ADDENDUM

ADDENDUM NO.: 01
PROJECT NAME: Sheridan Elementary School Annex
PROJECT NO.: 05075
CONTRACT NO.: C1581
DATE OF ISSUE: September 1, 2017

NOTICE OF CHANGES, MODIFICATIONS, OR CLARIFICATIONS TO CONTRACT DOCUMENTS

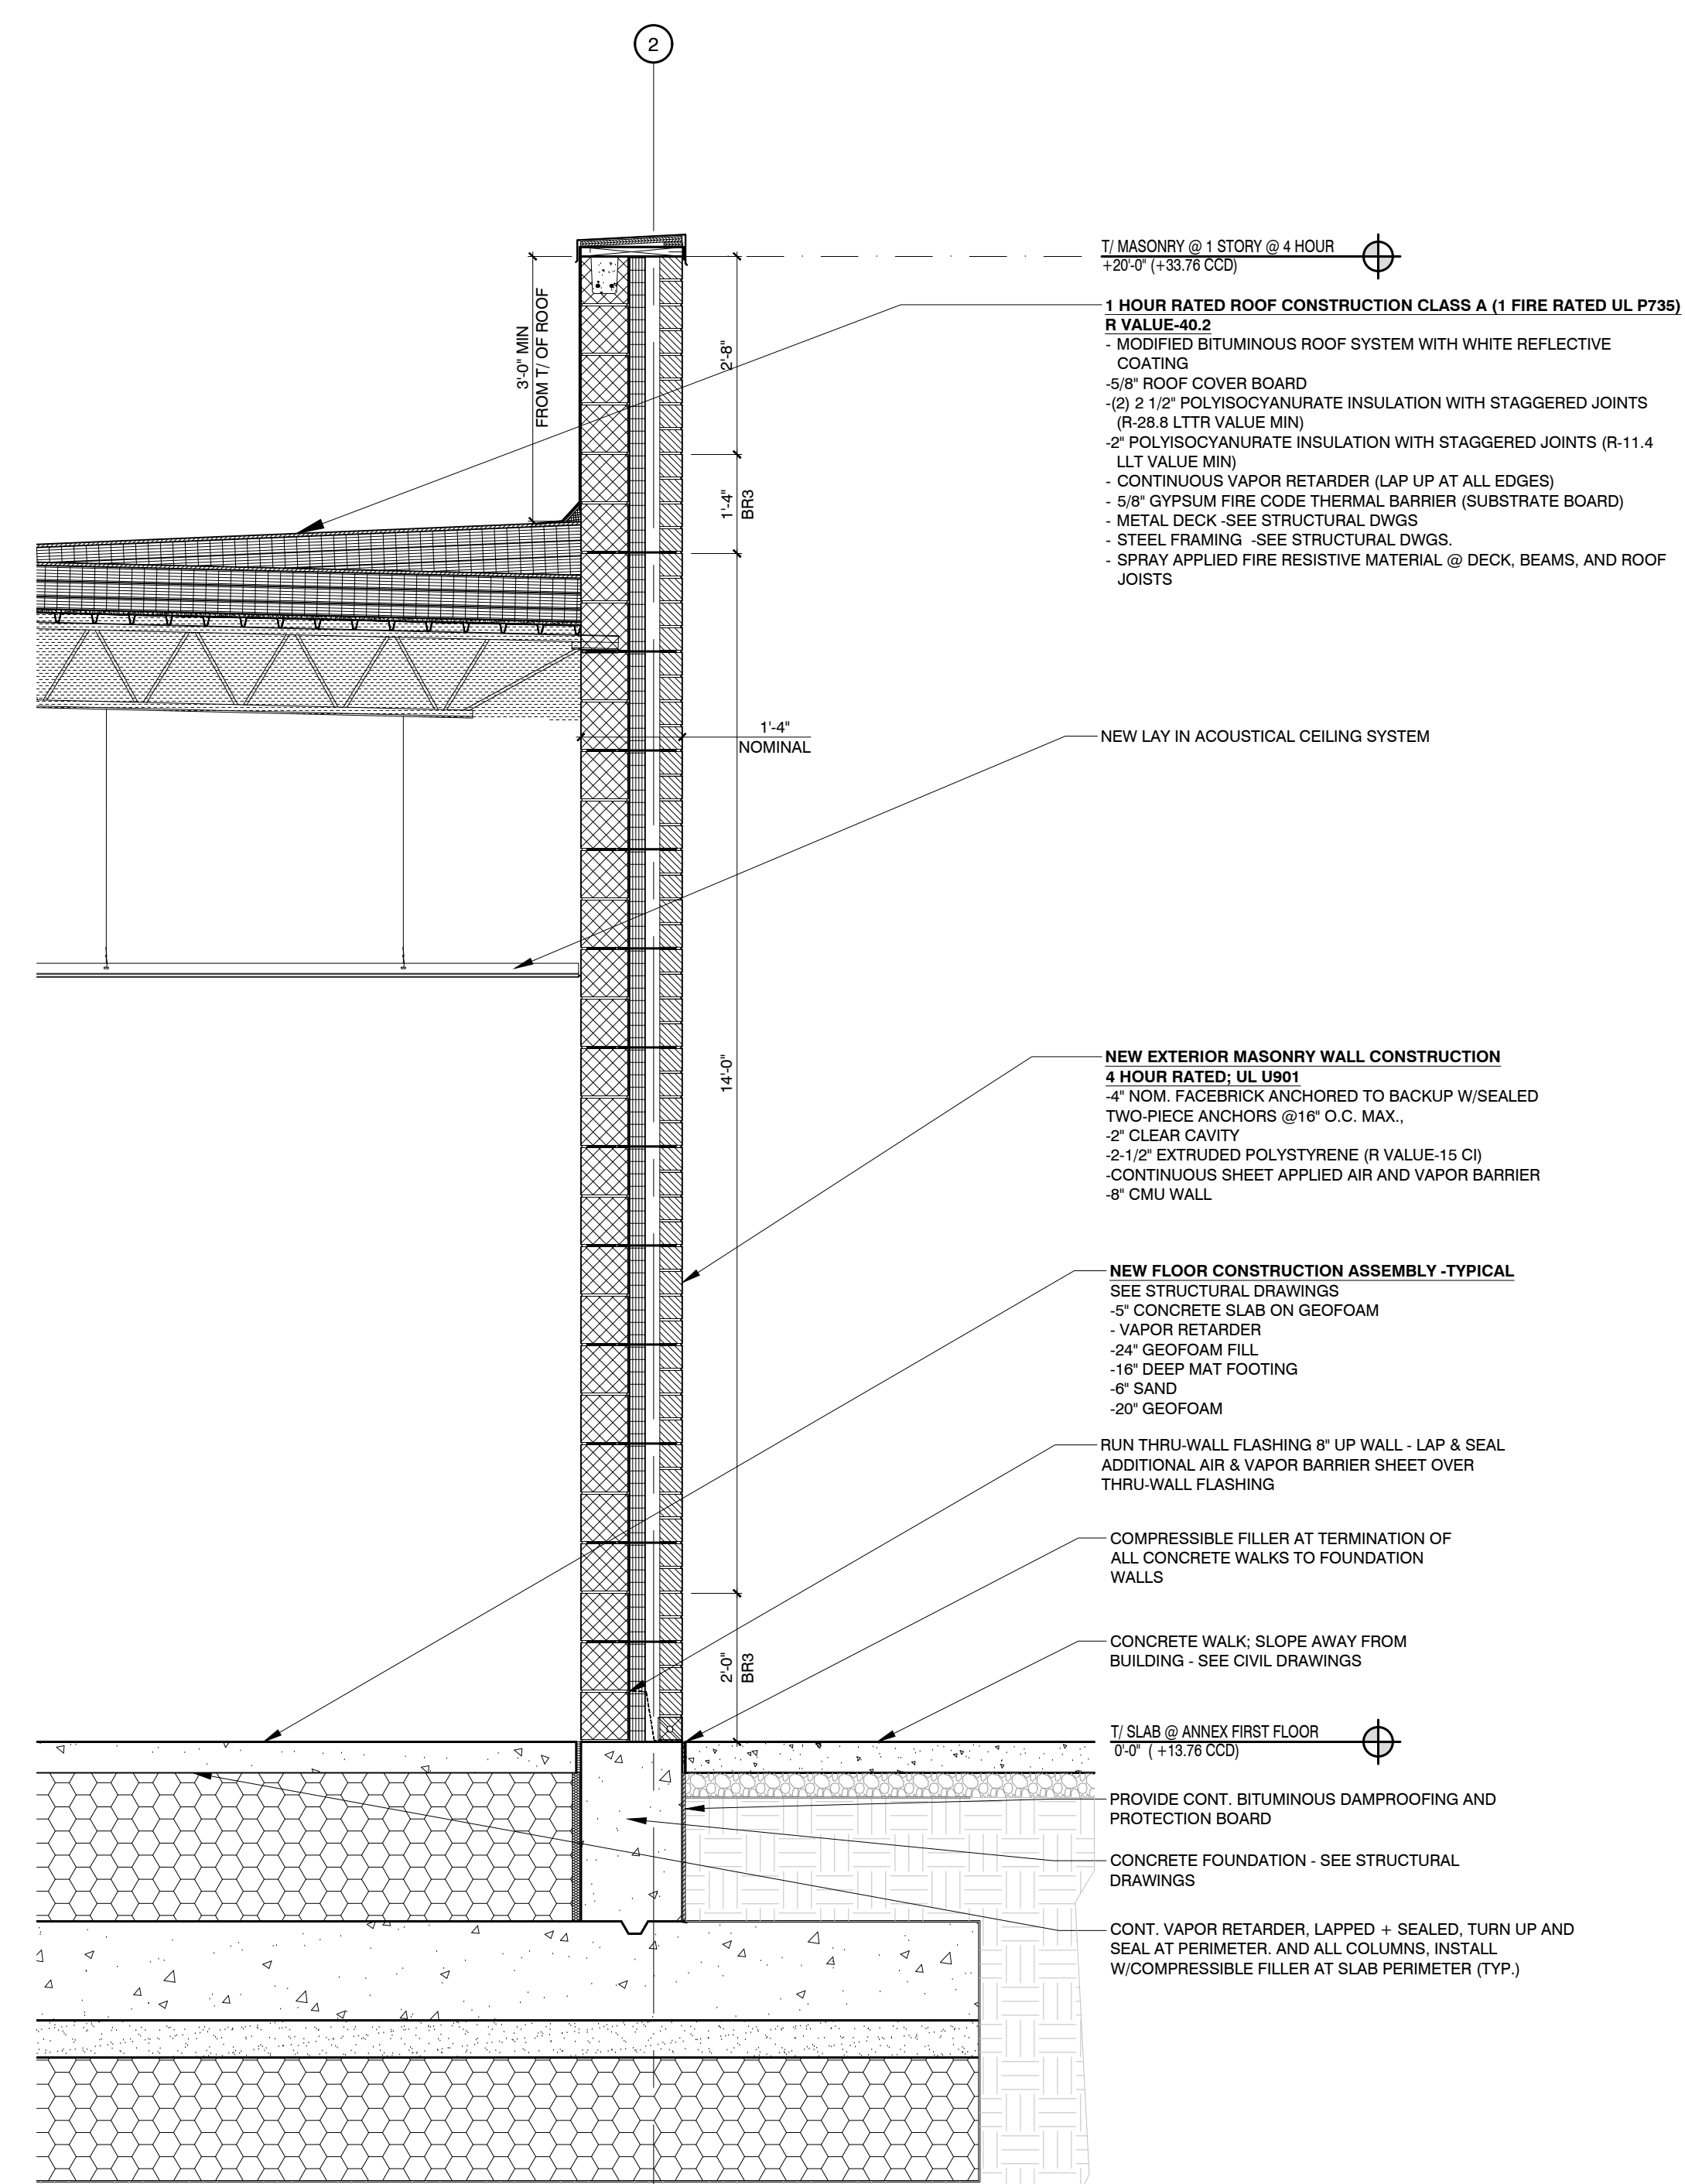
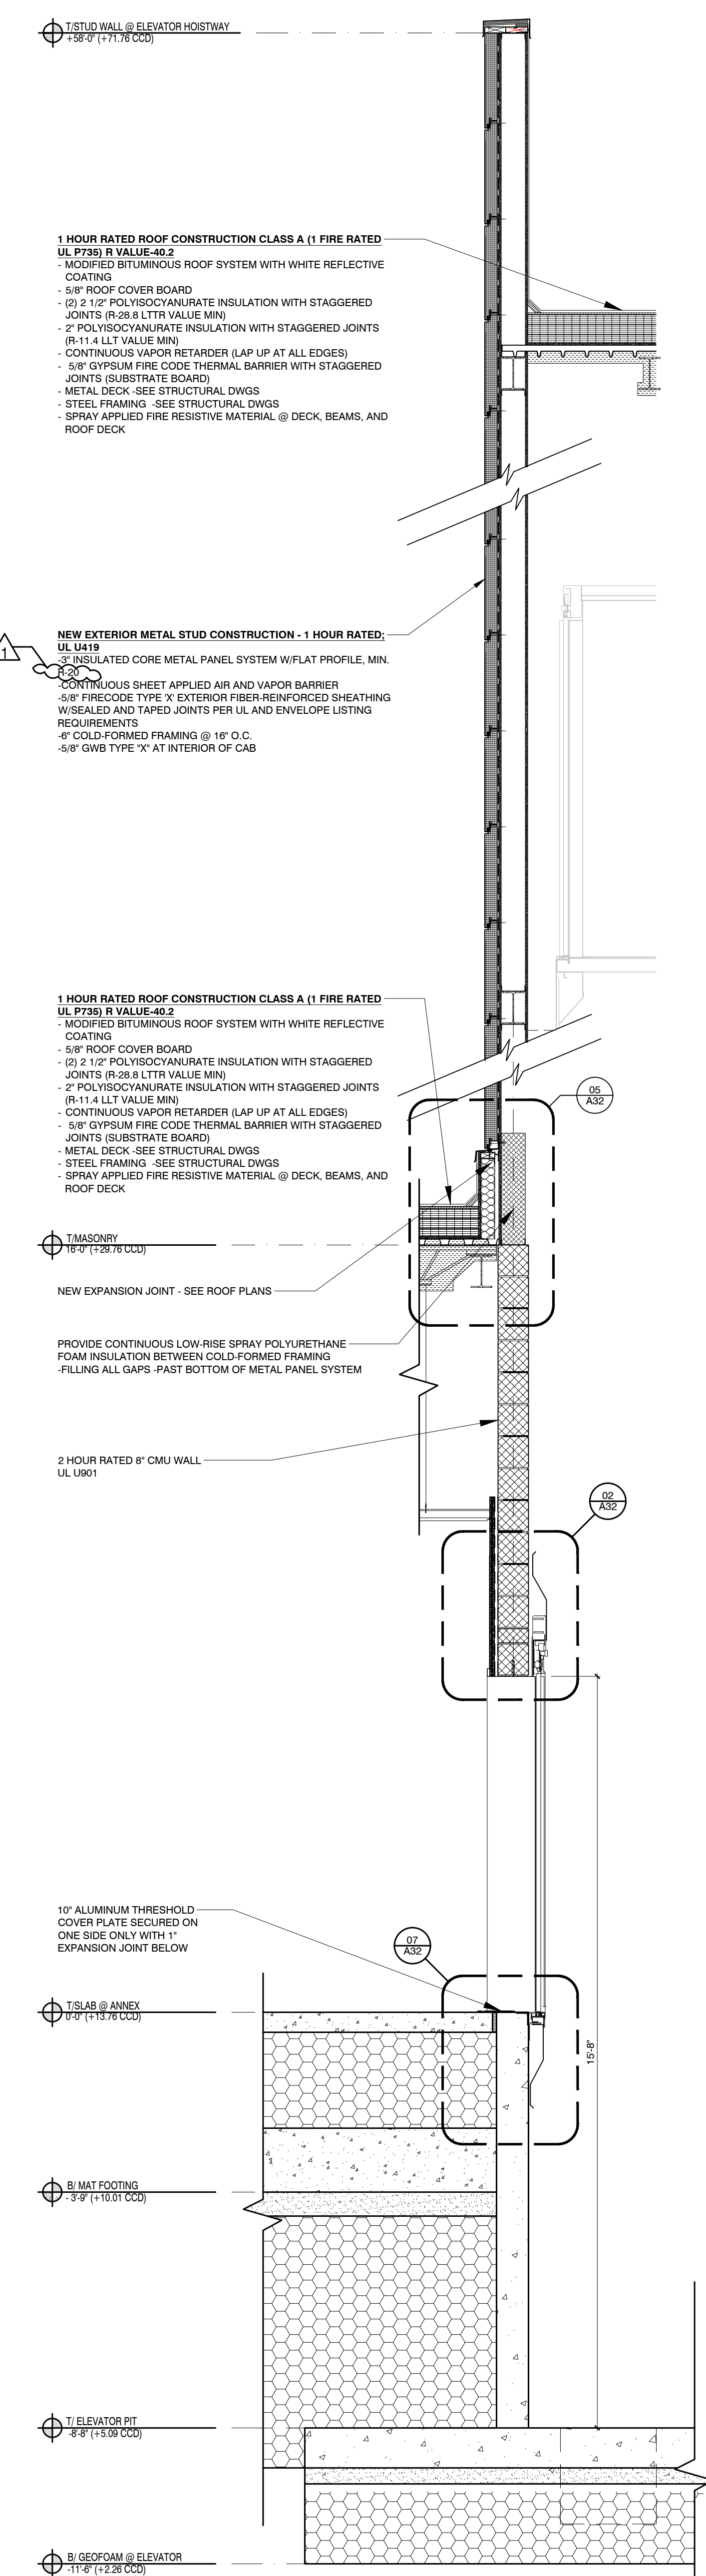
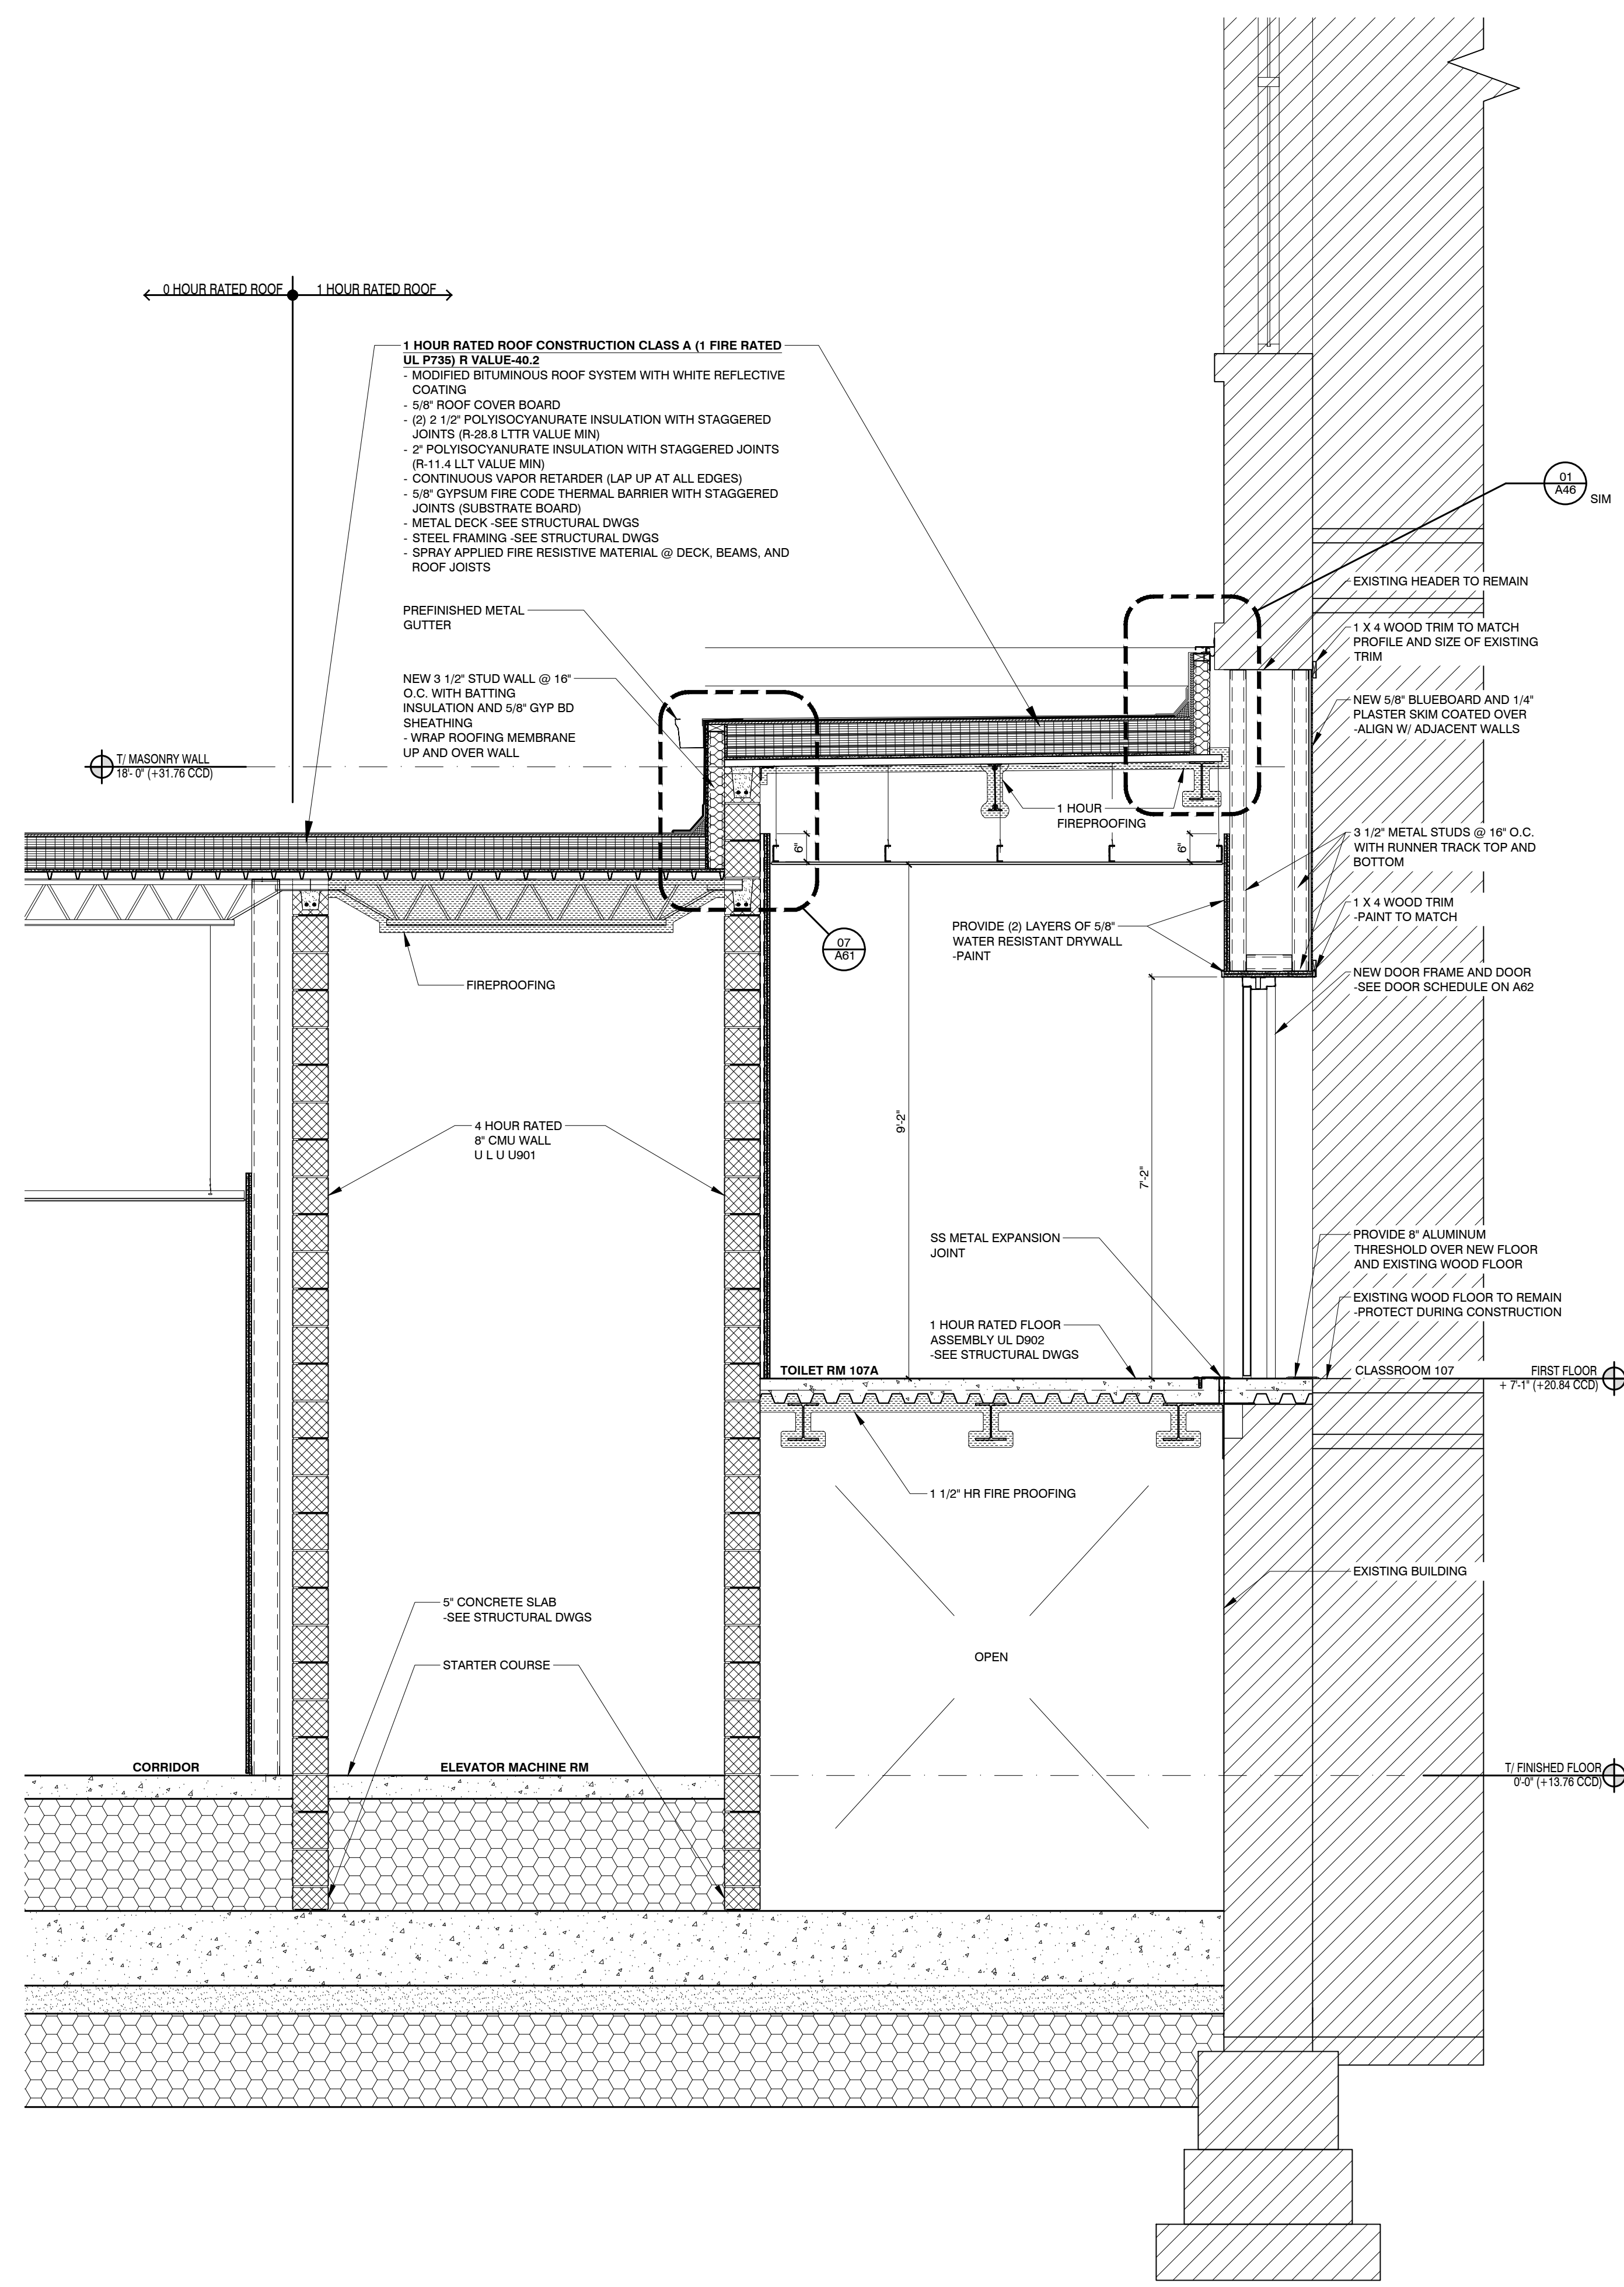
- Change 7. REVISED** – Drawing No. A32 – ELEVATOR SECTION & ELEVATOR DETAILS: Increased R value of insulated metal panels at elevator to R-20
- Change 8. REVISED** – Drawing No. A34 – WALL SECTIONS: Increased R value of insulated metal panels at elevator to R-20
